ARDROSSAN HARBOUR REDEVELOPMENT PROJECT MARINE WORKS LONG LIST OPTIONS

04/02/19

ARDROSSAN HARBOUR DEVELOPMENT PREFERRED BERTH OPTION REVIEW

BERTH WORKSHOP 12TH FEBRUARY 2019

Option 12	
Primary Berth	Winton Pier
Secondary Berth	Arran (or Irish)
Arran Berth Works	
• Left as-is / maintenance works	
Winton Pier	
• New linkspan	
• Fendering	
• Possible breakwater enhancement TBC	
• Possible need for dredging at turning area

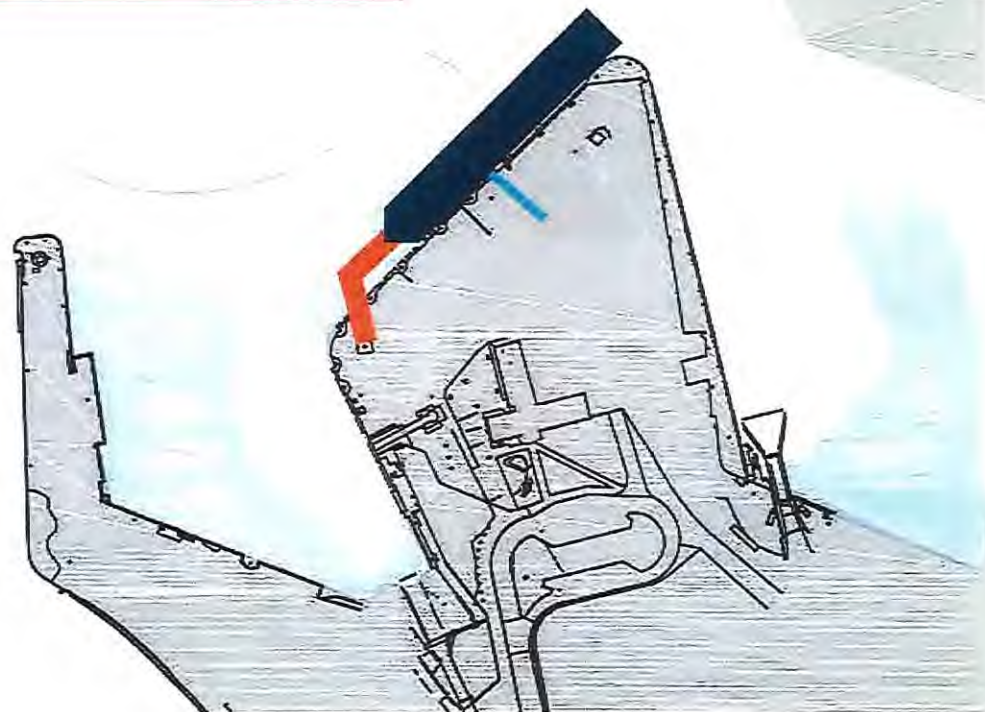
12 was not ruled out by Calmac and they could see the benefits but the devil will be in the detail of the geometry.

- Vessel can enter the harbour and use the turn to scrub off speed as current happens.
- could be challenging in certain wind conditions
- Wave climate / exposure needs exploring
- Linkspan needs protecting as potentially vulnerable to vessel strikes
- Potentially puts existing Arran berth out of use full time
- Linkspan geometry needs some work.
- Landside not ideal but it does work fairly well
- Agreed that Ramboll will initially do some more work on the linkspan geometry (two lanes of traffic) and then see if this should be taken forward some more but on the whole fairly well received.
- Both 12 and 13 have less construction work involved and are likely to be cheaper and quicker than Option 2, 6/7.

Taken Forward

Option ~~14~~ 13

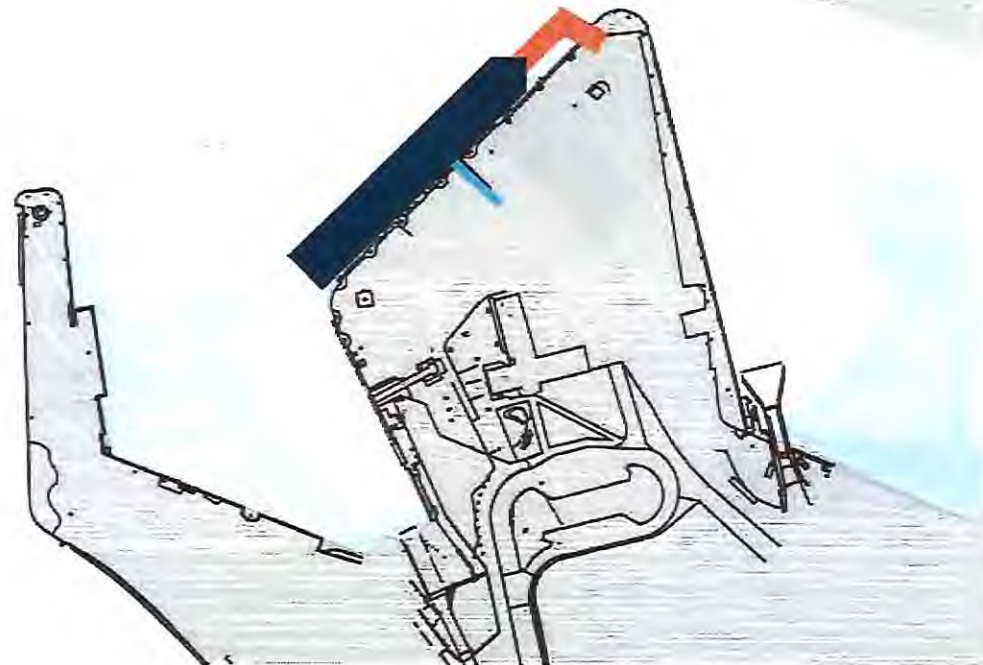
- As with 12 this was generally seen as a potential and worth exploring if the geometry works.
- Has added benefit over 12 that the Arran berth remains usable however probably blocks access to Irish berth (linkspan geometry to be confirmed)
 - Bow in berthing would give a problem of trying to stop in the available space.
 - Alternative would be to berth stern in and use the same turn as 12 to reduce speed.
 - Final manoeuvre on and off berth in this instance all under power (no roundhead or the like to walk round) so challenging but not insurmountable.
 - Landside is less favourable than 12 due to longer distances but is still workable.

Taken Forward

Option 15 14	
Primary Berth	Marina Pier
Secondary Berth	Arran (or Irish)
Arran Berth Works	
• Left as-is / maintenance works	
Marina Pier	
• New linkspan	
• Fendering	
• Dredging

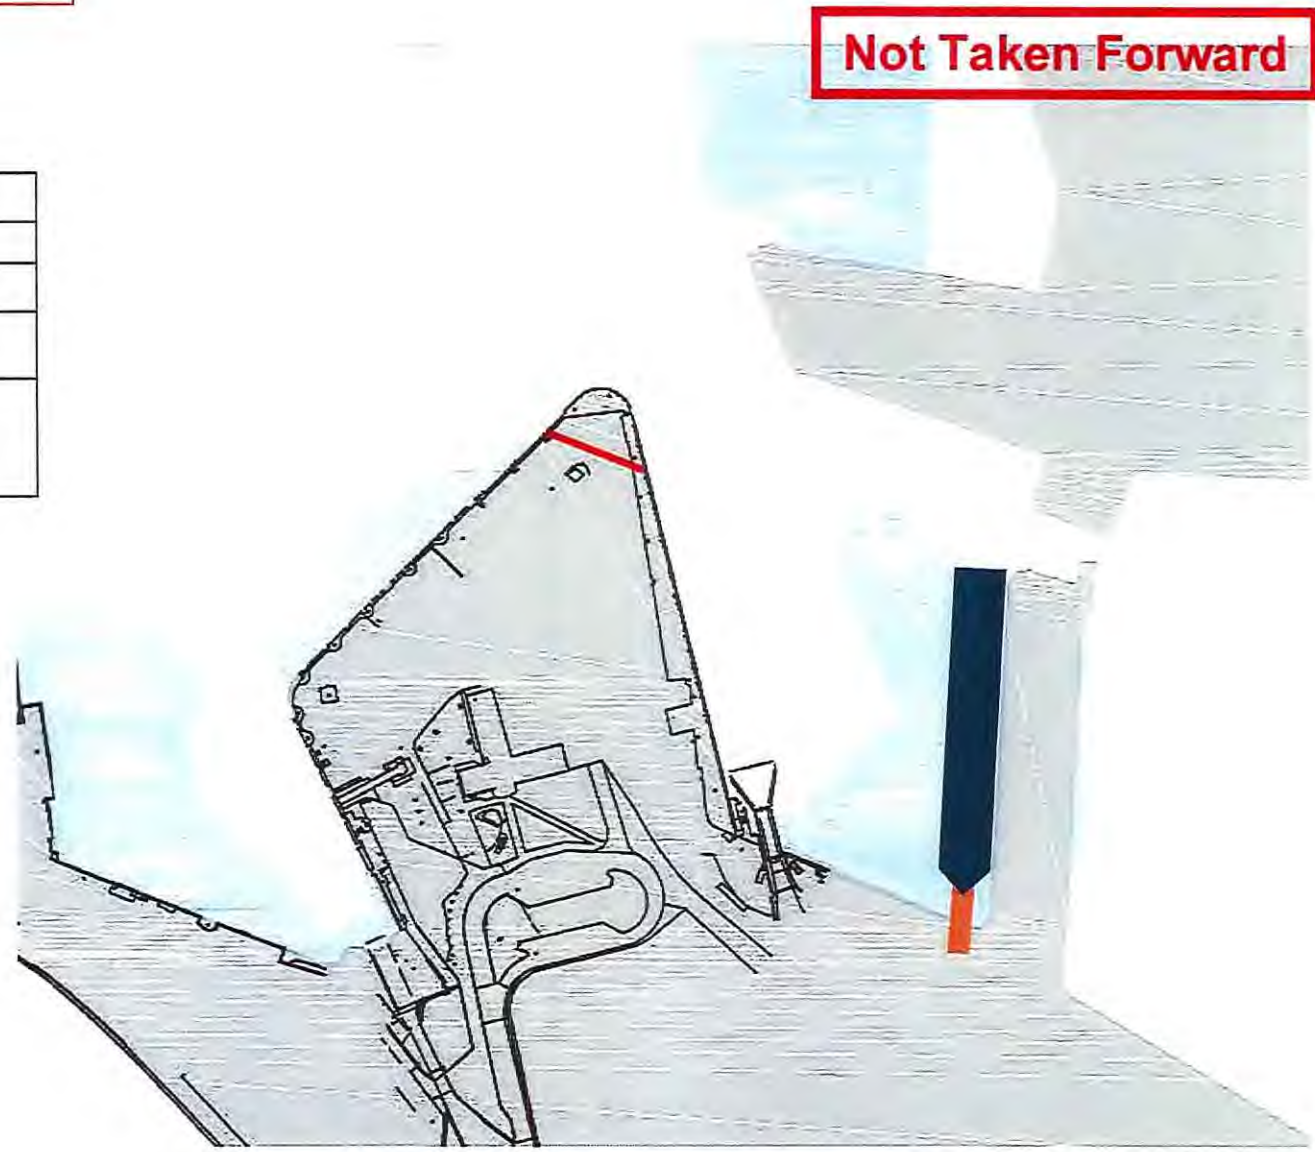
Too many unknowns and not discussed in any detail.

Not Taken Forward
